# BCA Assessment Report

REF Submission - Design Development Phase  
Batemans Bay Community Health  
7 Pacific Street, Batemans Bay NSW 2536

**Revision 3**  
15 July 2024  
Reference: 240062

Figure No. 2 – Rooms identified as 'Treatment Rooms' do not contain a use that triggers a Class 9a use

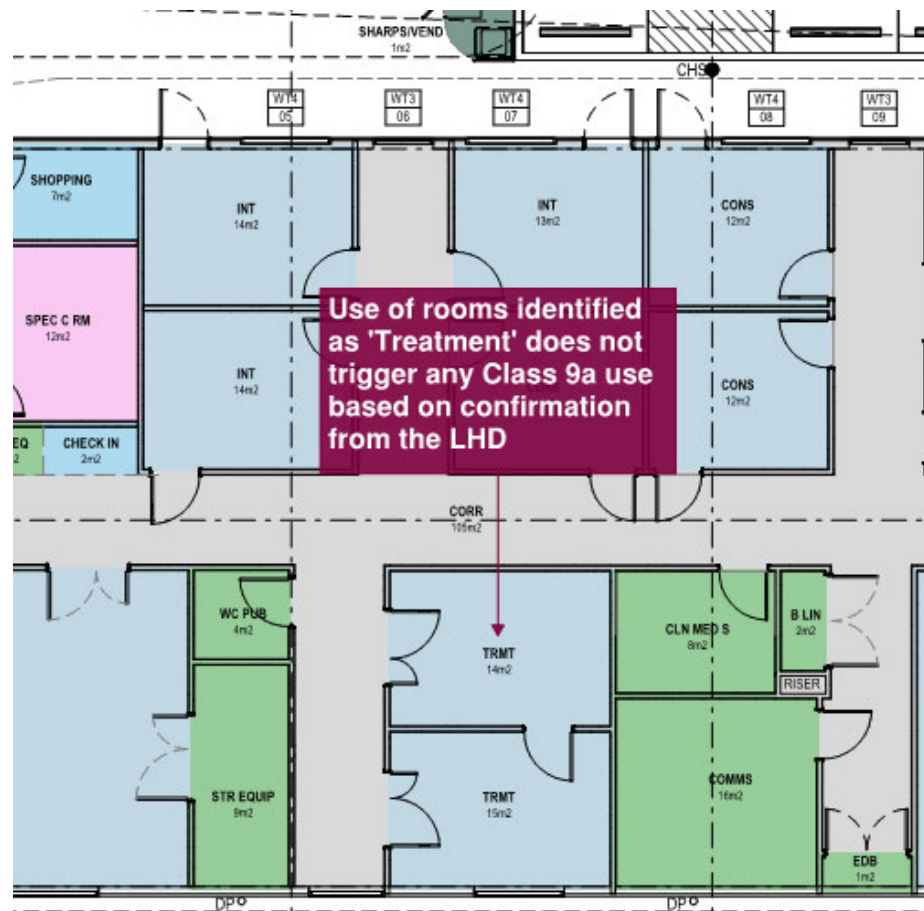
It is noted that the Community Health Building contains two (2) rooms that are identified as treatment rooms.

The LHD has provided the following response in terms of the use rooms:

*'The main treatment administered by community nursing would be wound care, catheter management, case management in addition to other assessment and treatment of minor issues. There will be no use of nitrous gases, sedatives or anaesthetics in this space that would inhibit a patient's ability to evacuate in case of an emergency'.*

As a result of the written confirmation from the LHD, the use of the rooms does not trigger any Class 9a use and thus the classification of Class 5 applies to the entire building.

Figure No. 3 – Exposure of external walls of the Community Health Building to the Temporary Demountable Building

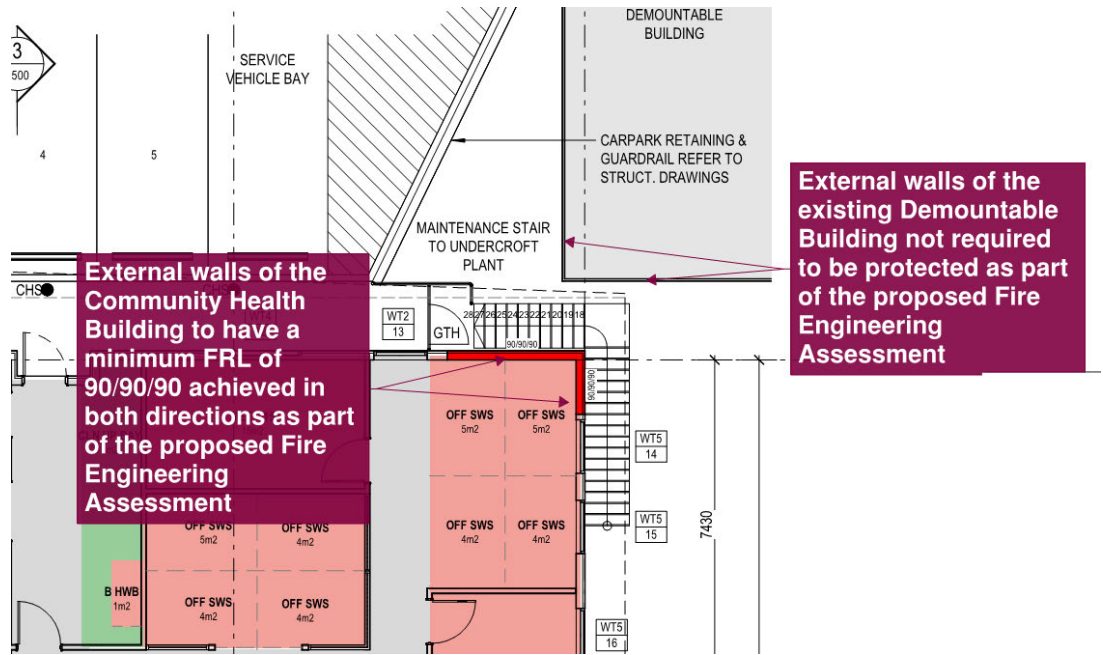
The external walls of part of the Northern Elevation and Eastern Elevation that are situated less than 3 m from the Temporary Demountable Building on site will be required to be provided with an FRL in order to comply with Specification 5. This would require the parts of the external wall to have an FRL of 90/90/90 (if less than 1.5m) and 60/60/60 (if less than 3.0 m).

Due to the fact that the proposed development is causing a non-compliance with the respect to the existing Demountable Building on site, the external wall of the Demountable Building and any associated openings that are situated less than 3 m from the Community Health Building would also be required to be provided with an FRL.

Due to the impracticality of providing an FRL to the existing wall of the Demountable Building, the proposed design solution is for the external wall of the Community Health Building to be protected in both directions.

In this instance, the proposed protection of the external walls and any associated openings of the Community Health Building and existing Demountable Building is proposed to be assessed as part of the Fire Engineering Assessment to be undertaken by Arup in order to demonstrate compliance with the nominated Performance Requirements of the BCA.

It is noted that the proposed Fire Engineering Assessment by Arup requires the external walls of the Community Health Building that are situated within 3m of the existing Demountable Building to be provided with an FRL of 90/90/90 which is achieved in both directions. Based on the external wall of the Community Health Building being protected in both directions as part of the Fire Engineering Assessment, there is no requirement for the external wall of the existing Demountable Building to be protected.

Figure No. 8 – Gate provided from the courtyard area on the Western Elevation of the building

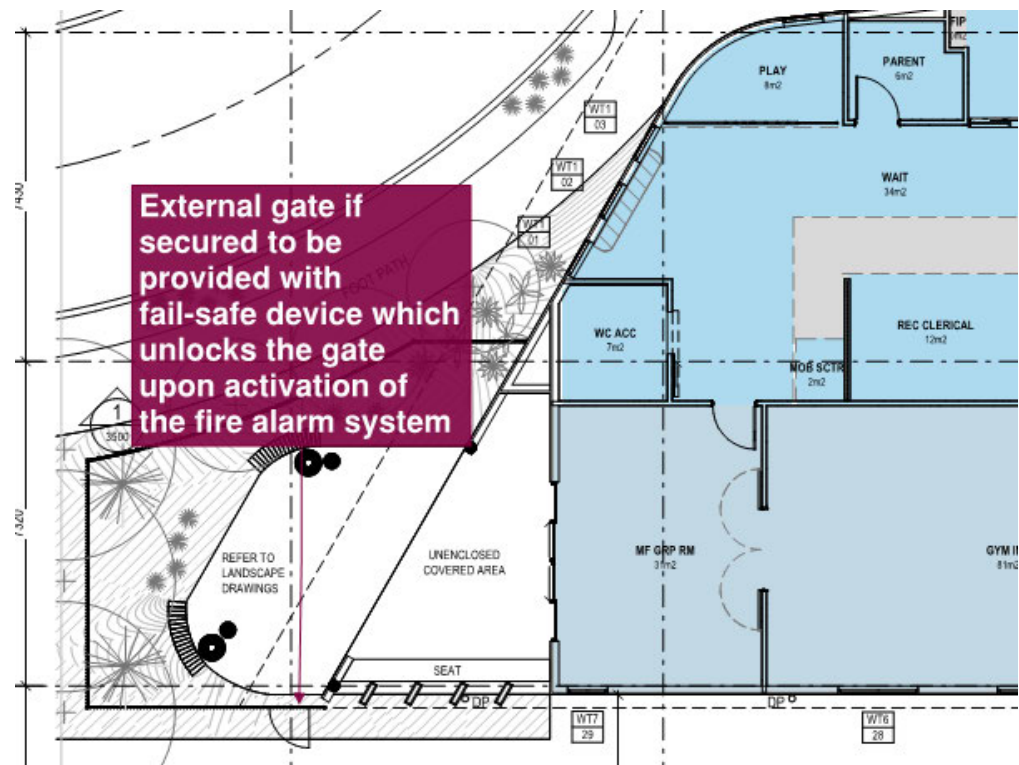
Based on the provision of exits as detailed in the figure above, travel distance between alternative exits complies.

Figure No. 23: Doorways where circulation space is required to be reviewed in detail to ensure that compliance is achieved

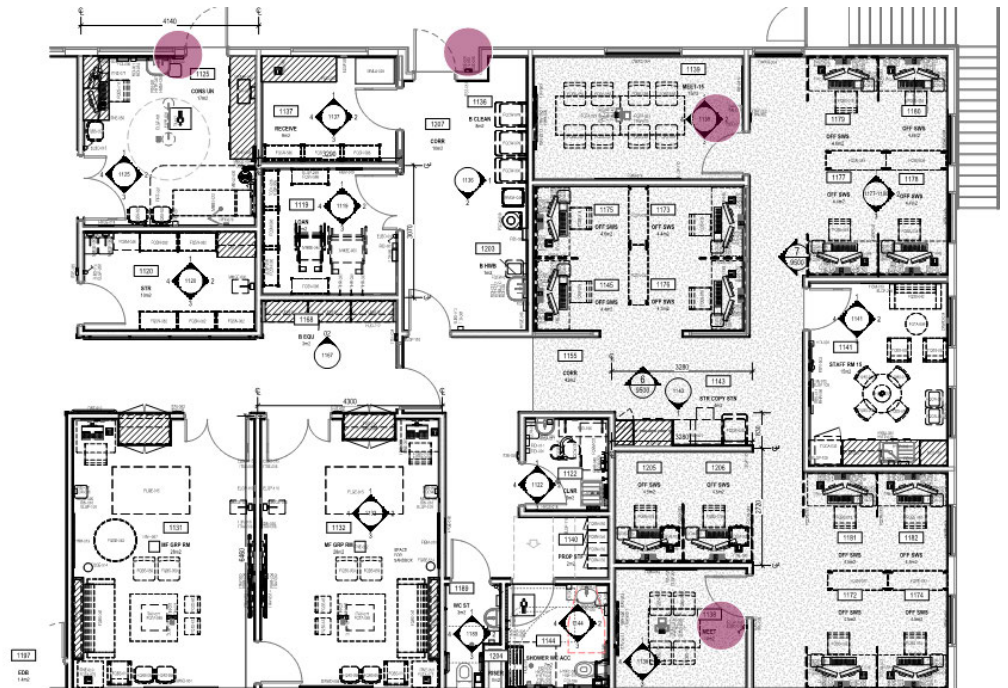
From a review of the Design Development Drawings, circulation space is currently deficient or requires close attention to the following doorways to ensure that compliance is achieved in accordance with AS 1428.1 – 2009.

Figure No. 43: Proposed accessible car parking spaces for a person with a disability in proximity to the main entrance of the building

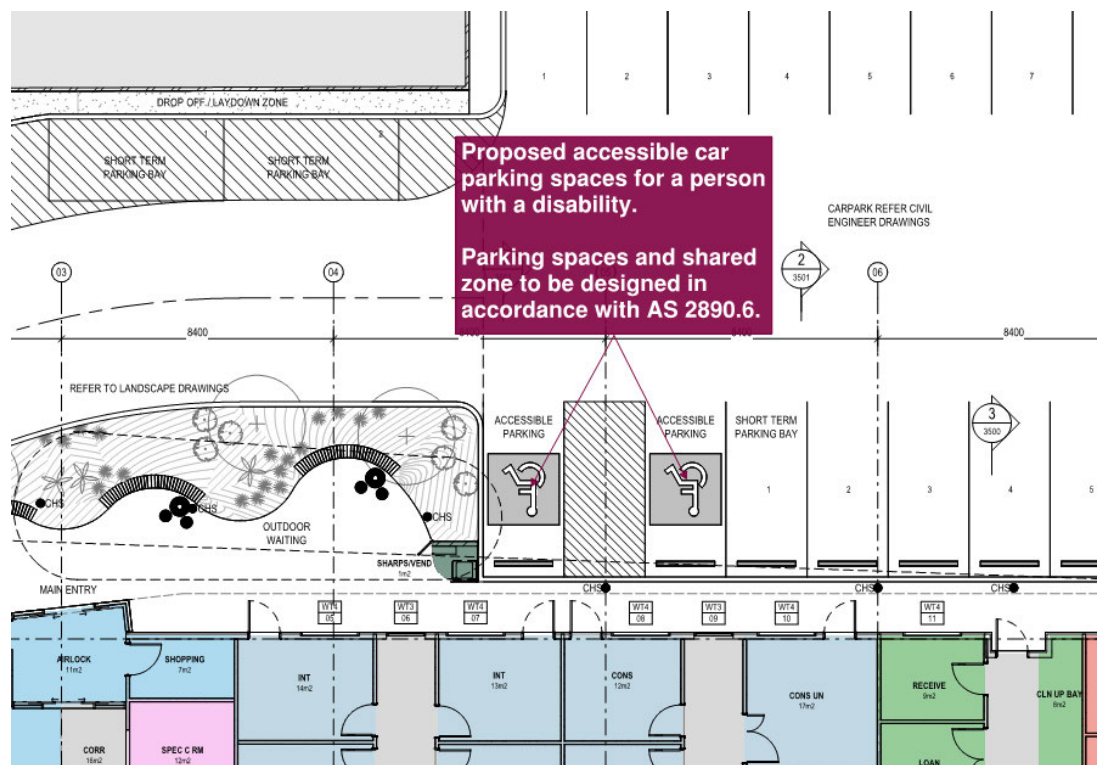
The Design Development proposes two (2) accessible car parking spaces which ensure compliance with Clause D4D6.

The accessible car parking spaces will be required to be designed and constructed in accordance with AS 2890.6.

Figure No. 46: Location of proposed external fire hydrants serving the Community Health Building

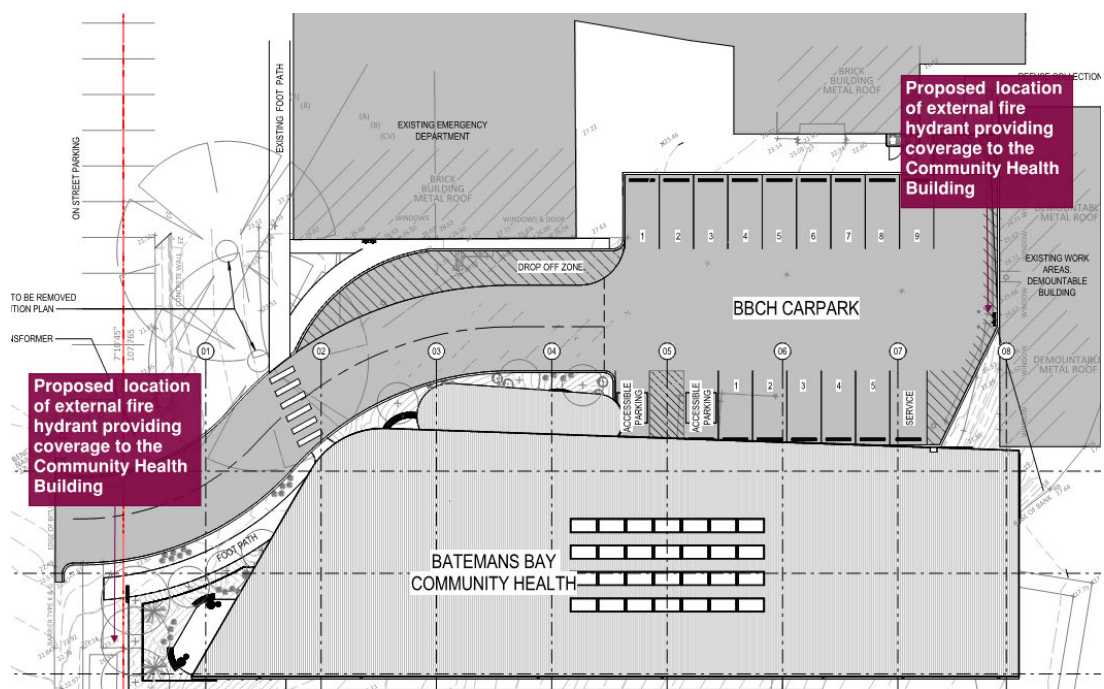
The proposed locations of the external fire hydrants are more than 10 m from the external walls of the proposed building they are providing coverage to. The fire hydrant within the car park which is within 10 m of the external wall of the demountable building is not a non-compliance as the fire hydrant is not providing coverage to demountable building.

Figure No. 47: Unimpeded access required to external fire hydrants

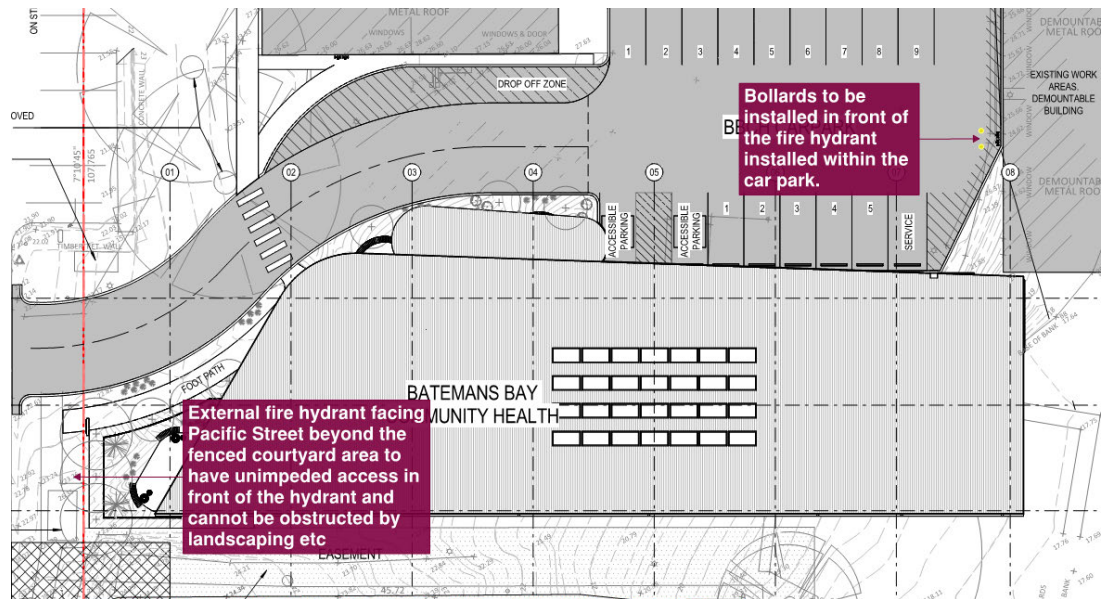
The external fire hydrant installed within the car park will be required to have bollards installed in front so that the booster cannot be obstructed by a parked motor vehicle. The external fire hydrant

installed facing Pacific Street is required to have unimpeded access in front of the hydrant and cannot be obstructed by landscaping etc.

*Figure No. 48: Location of existing fire hydrant booster serving the Batemans Bay Hospital site relative to the Main Entry of the proposed Community Health Building*

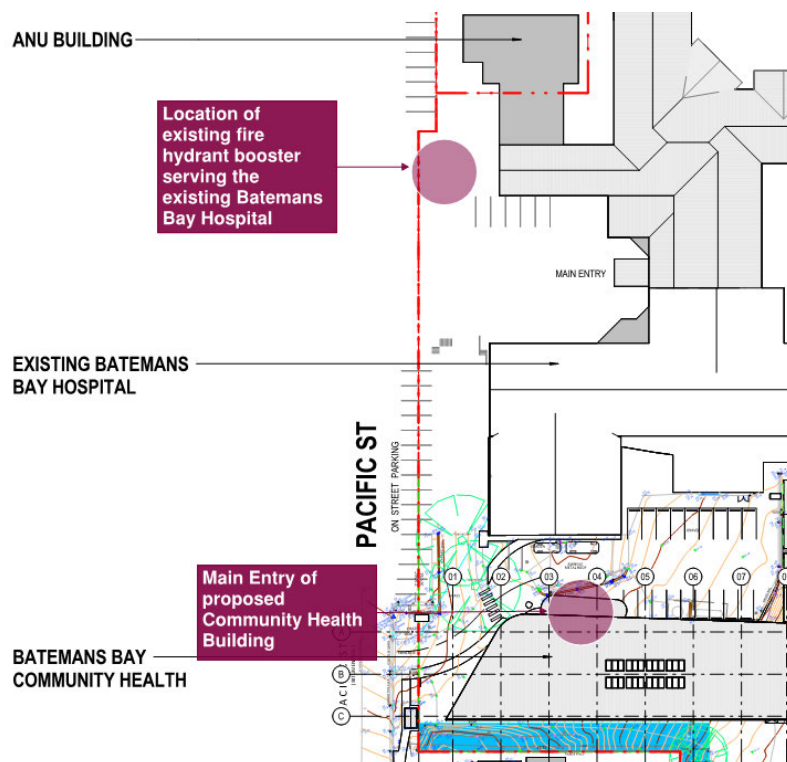
The existing fire hydrant booster serving the existing Batemans Bay Hospital Site is located facing Pacific Street. The existing fire hydrant booster will be relied upon to serve the proposed Community Health.

Having regard to the location of the existing booster relative to the main entrance of the proposed Community Health Building, compliance cannot be achieved with Clause 7.3 of AS 24198.1 – 2021 which requires the booster to be located within sight of the principal pedestrian entrance of the building.

Figure No. 49: Location of Main FDCIE within the existing hospital and sub FDCIE within the Community Health Building

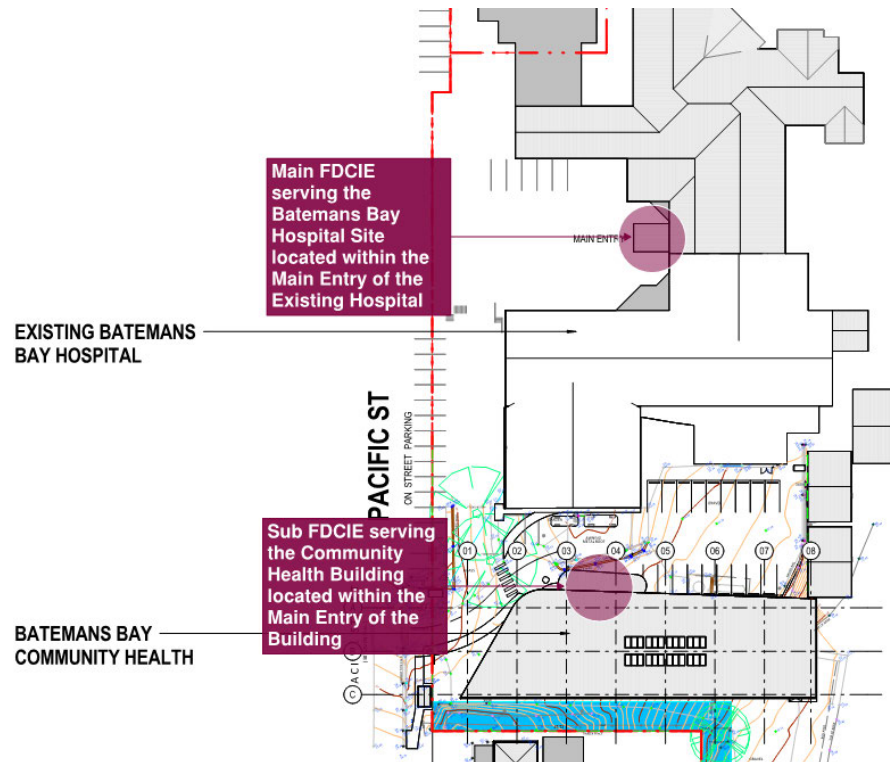
Fire Detection Control Indicating Equipment (FDCIE) will be installed within the Main Entry of the Community Health Building. The new FDCIE will be connected to the main FDCIE (located at the main hospital) and will act as a sub-panel. The main panel is readily accessible and new block plans will be provided to indicate the Community Health Building and new sub-panel.

It is noted that the Fire Services Designer (GHD) has provided written verification that the Automatic Fire Detection & Alarm System is not required to be extended to the building undercroft due to its open nature and the spurious alarm nature of the undercroft area.

Figure No. 51: Proposed staff sanitary facilities

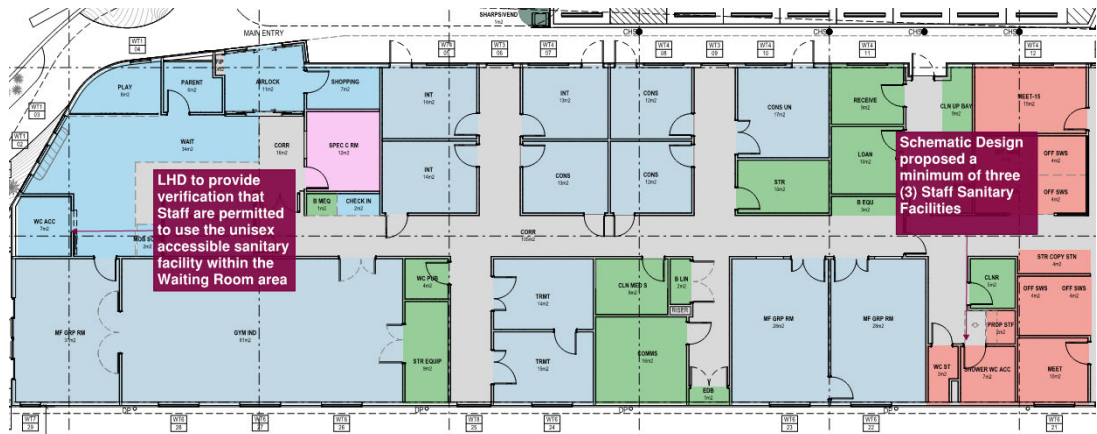
If the unisex accessible sanitary facility located within the Waiting Room area can be used by staff and members of the public, then the total number of male staff can be increased to twenty-five (25).

Written verification is to be provided from the LHD that the unisex accessible sanitary facility within the Waiting Room area can be used by LHD staff.
